Planning Commission Staff Report

Project Type: Site Development Section Plan

Location: Chesterfield Commons Seven, Lot 2

Description: **Chesterfield Commons Seven, Lot 2 (Valvoline)**: A Site Development Section Plan, Landscape Plan, Lighting Plan, Architectural Elevations, and Architect's Statement of Design for a 0.977 acre tract of land zoned "PC" Planned Commercial District located on the north side of Chesterfield Airport Road, one-half mile west of the corner of Chesterfield Airport Road and Boone's Crossing.

SITE DEVELOPMENT SECTION PLAN
FOR VALVOLINE INSTANT OIL CHANGE OUTPARCEL 2 WITHIN CHESTERFIELD COMMONS SEVEN GOVERNING ORDINANCE # 2501

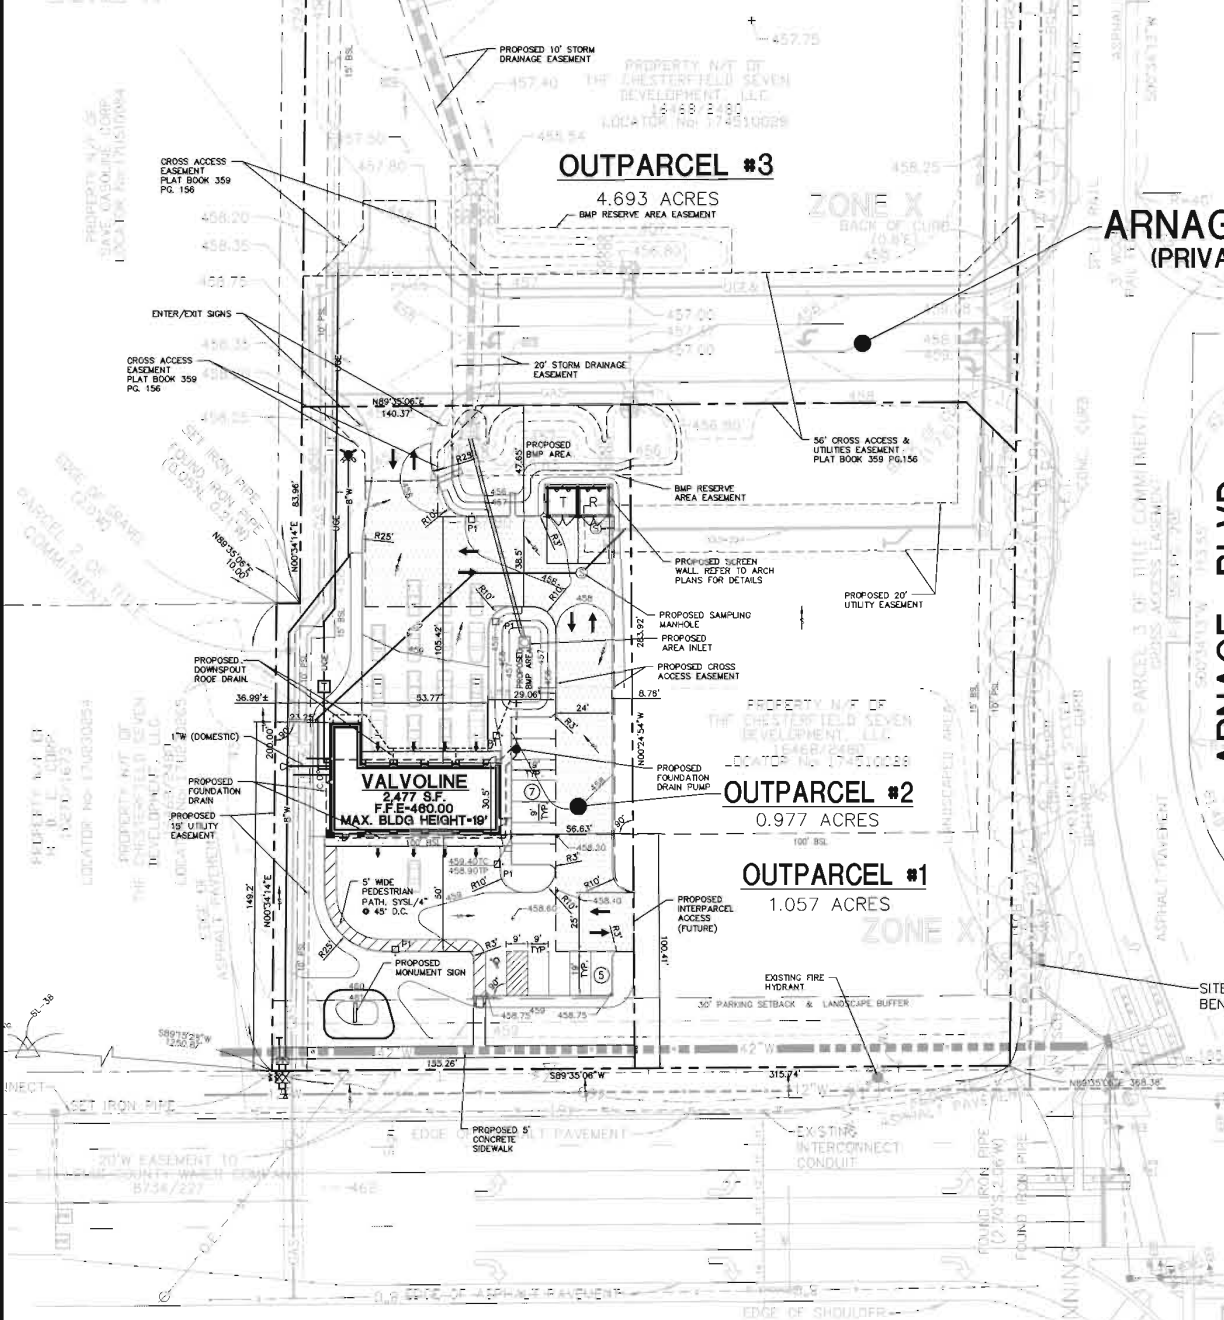
The subject site is zoned “PC” Planned Commercial District. The submittal was reviewed against the requirements of City of Chesterfield Ordinance 2501, and all applicable Zoning Ordinance requirements. The submittal as presented adheres to Ordinance 2501 and all applicable Zoning Ordinance requirements.

The circulation system into the site has been addressed through the approval of the Site Development Concept Plan. The primary roadway into the development is being constructed to align with the adjacent development to the east. An entrance off the internal street is being provided and no vehicular connection is allowed from Chesterfield Airport Road. Cross access to the adjacent lot to the east, that is yet to be developed, is being provided for ease of circulation within the development.

Parking for the site is provided to the east of the building and on the south side of the lot. The number of parking spaces provided meets the requirements of the Off-Street Parking, Stacking, and Loading Regulations section of the City of Chesterfield Zoning Ordinance.

SHEET
A-3

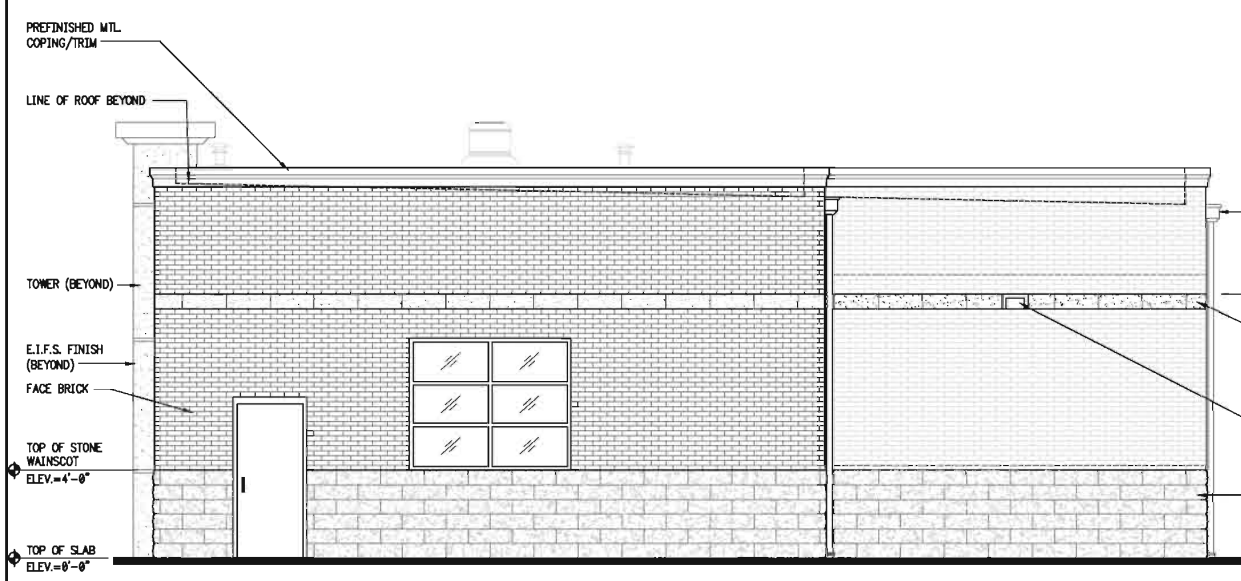
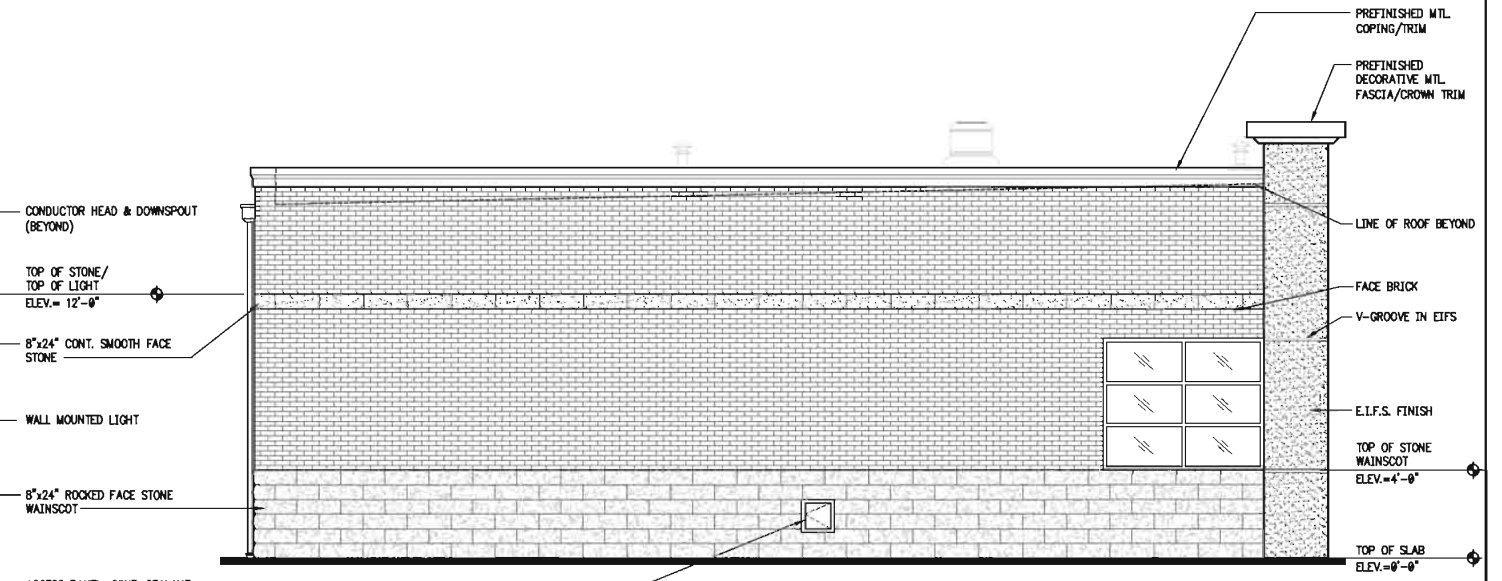
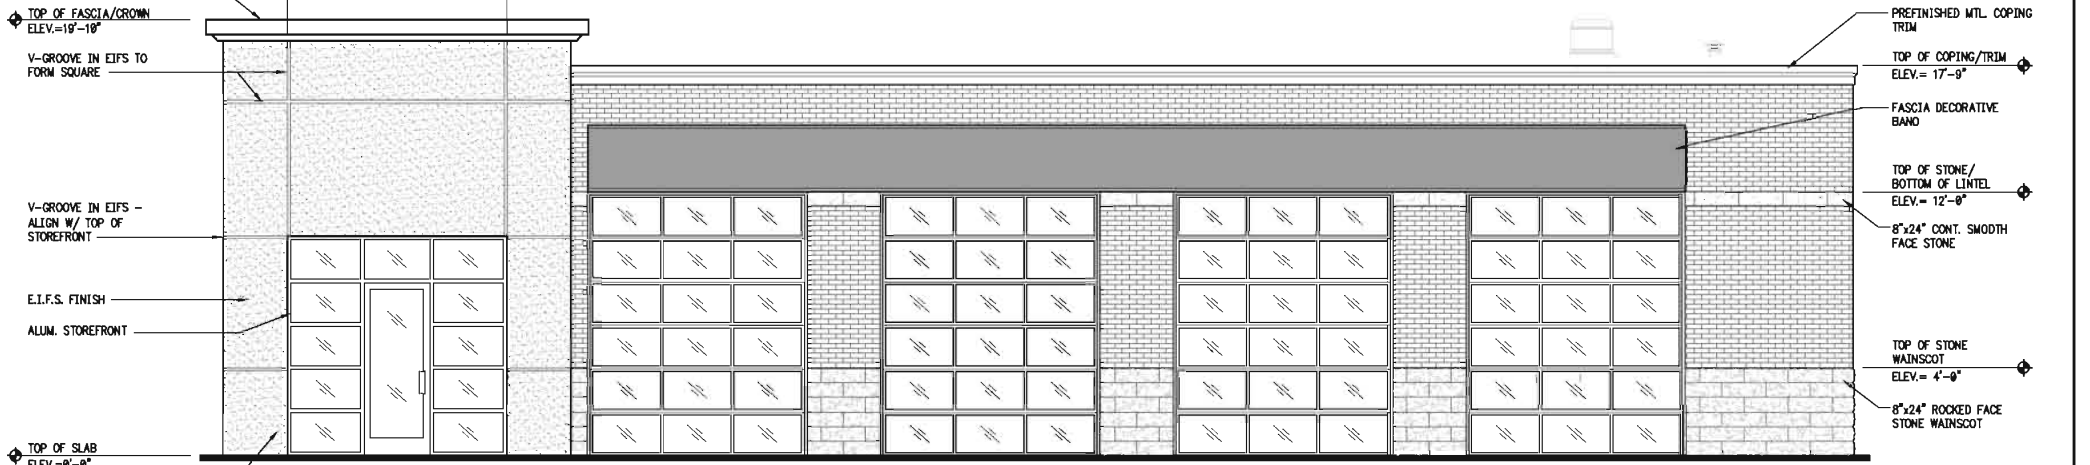
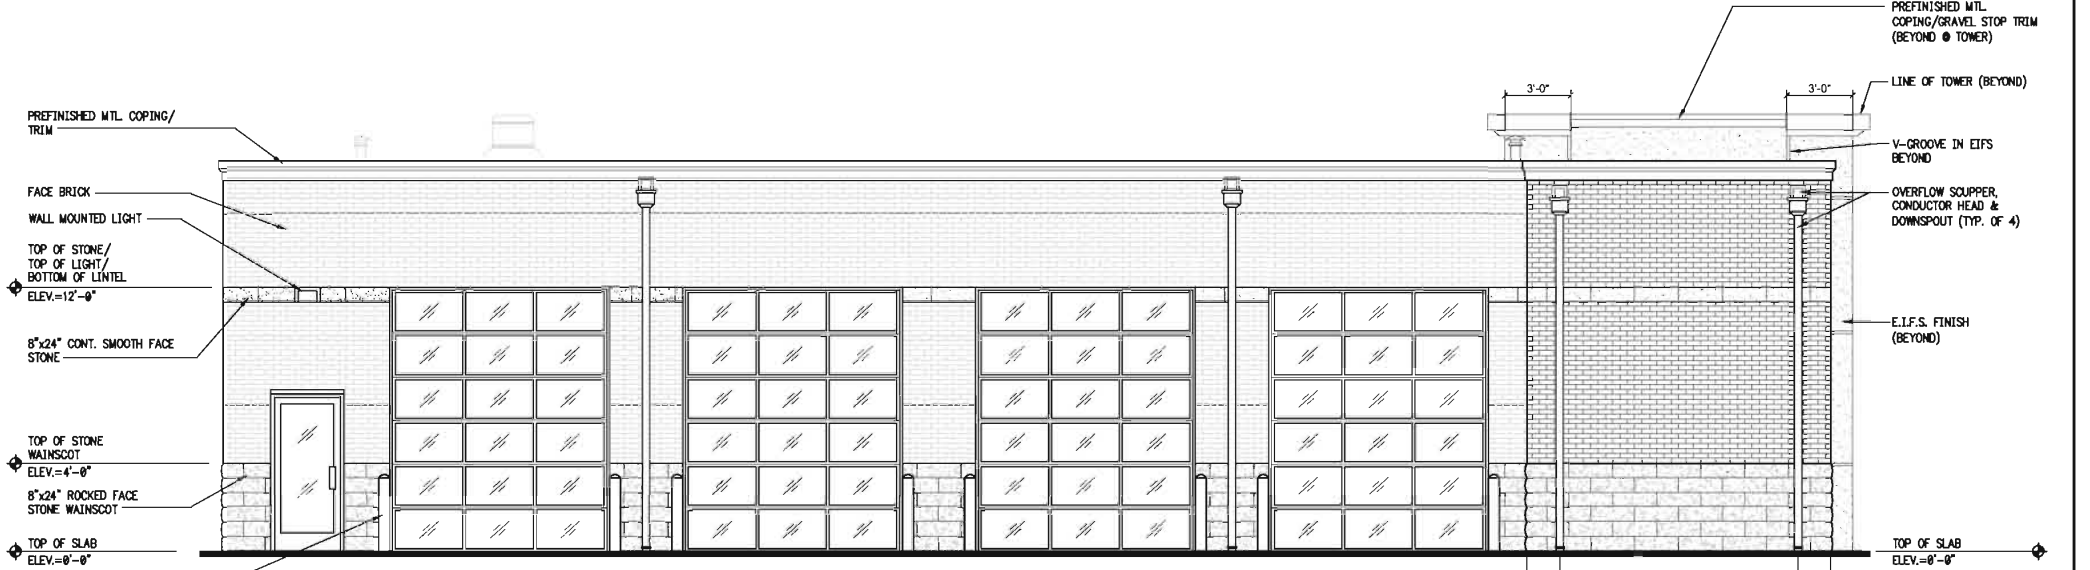
The project was reviewed by the Architectural Review Board on March 8, 2012. A motion was passed by a vote of 5-0 to forward the project to Planning Commission for approval as presented.

Chesterfield, MO Valveine Lighting Layout

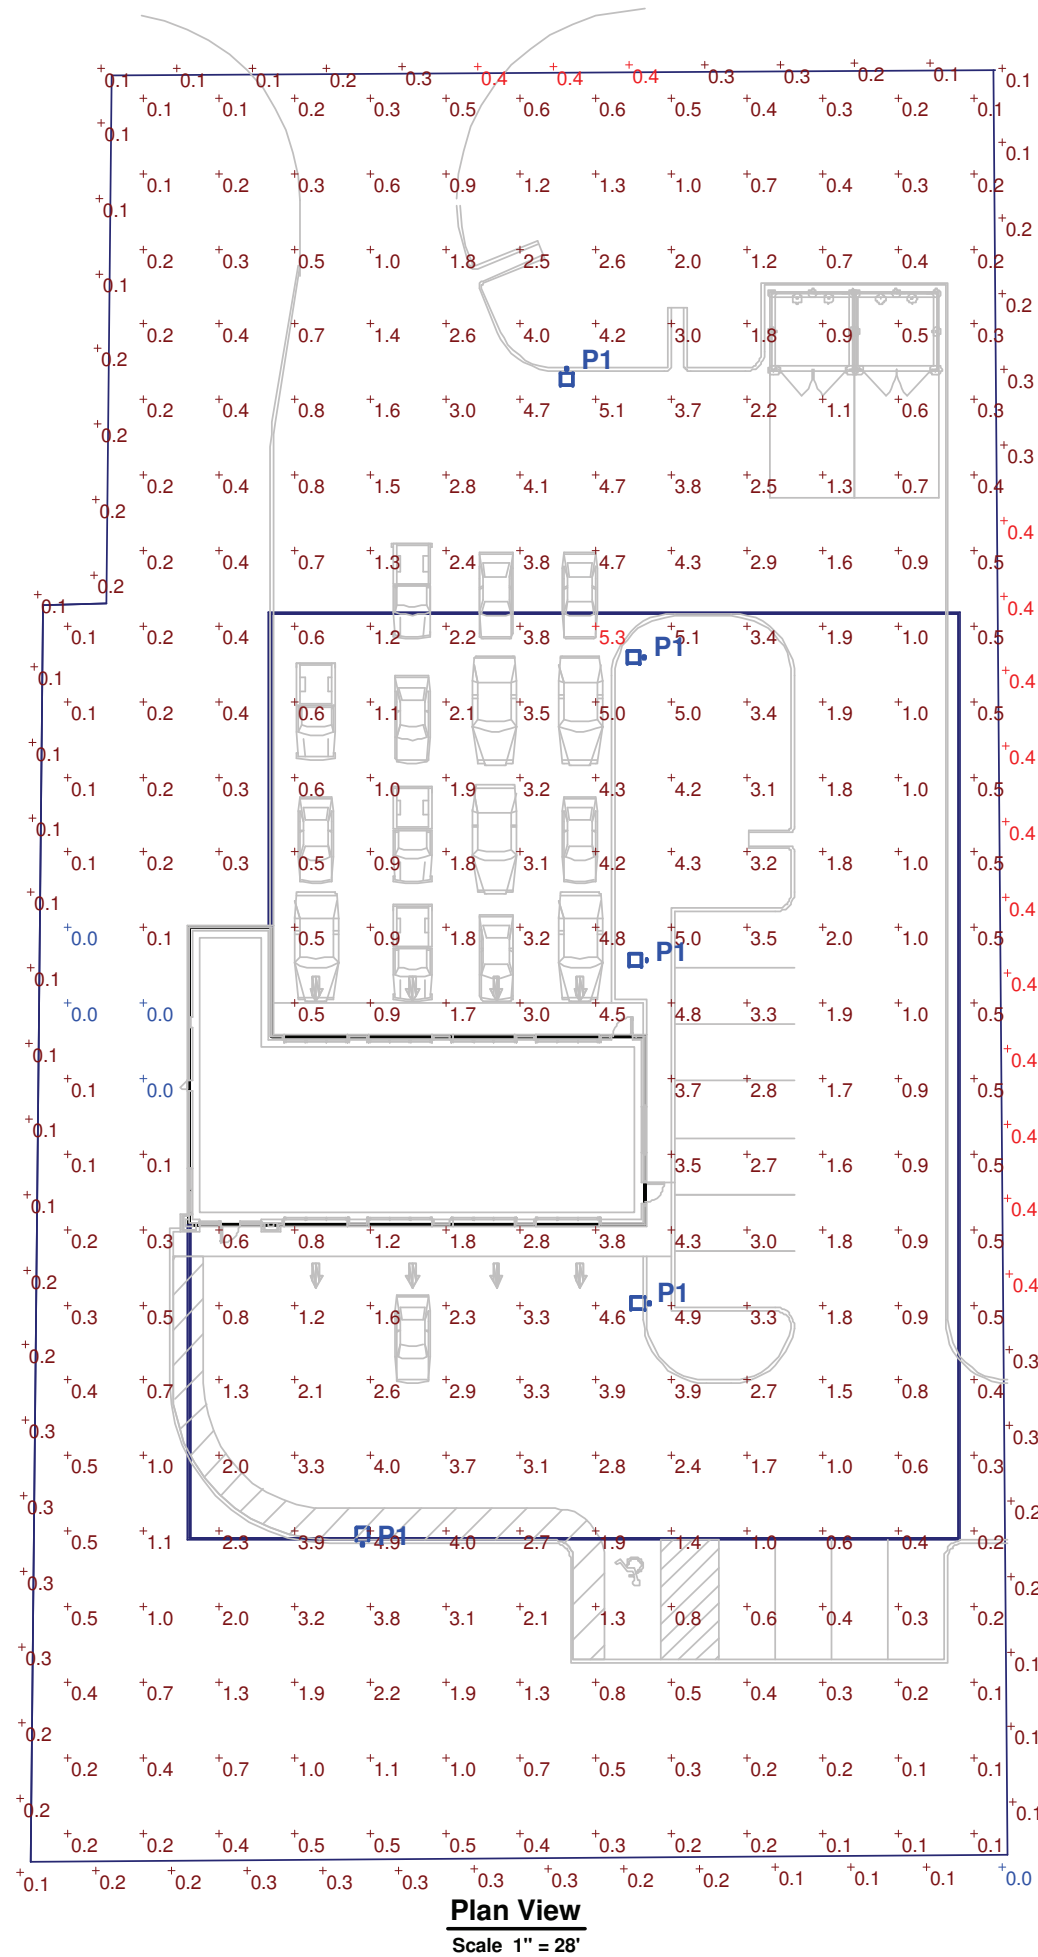
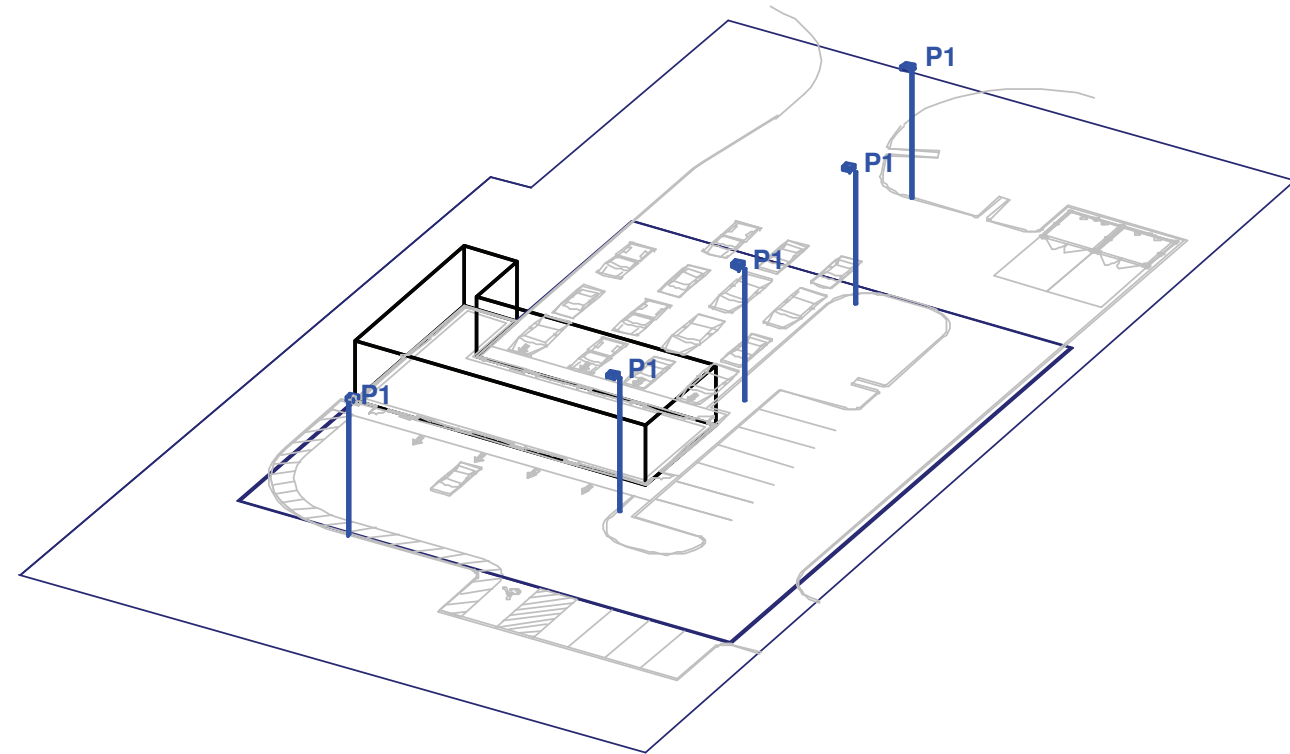
A Lighting Plan has been submitted with pole mounted parking lot fixtures in the parking lot. The fixture design adheres to the City of Chesterfield Lighting Ordinance however the proposed mounting height of the parking lot fixtures is thirty-three (33) feet. The Lighting Ordinance states that the height of all light standards shall be reviewed by the Planning Commission. The applicant has submitted a request to allow a mounting height of thirty-three (33) feet in order to be consistent with the height of the parking lot light standards found on the Chesterfield Commons Six site.
